TMC SPECIFICATION NO. S-351

TITLE: CN-109-A ADAPTION KIT FOR GPT-750 (RTP SECTION)

Replacement of C610, C601 and C602 in all GPT-750 transmitters having serial numbers lower than #212.

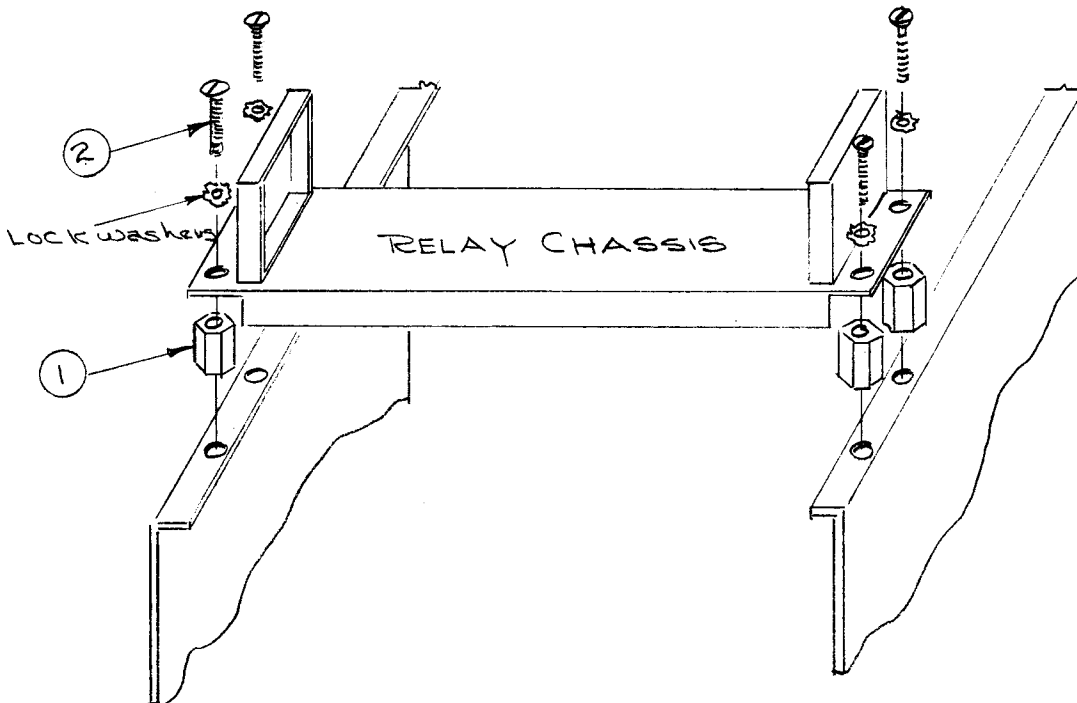
Increase the operating life of the capacitor.

When the capacitors are shipped, they must be sent with the items shown in chart below, which will allow a raising of the RTP Relay Deck. This is necessary to accommodate CN-109-A which is higher than CN-109 due to its higher voltage rating.

Step 1. Remove four screws holding Relay Deck and discard. (retain 4 lockwashers)

Step 2. Reassemble Relay Deck as shown, using item 1, item 2, and lockwashers.
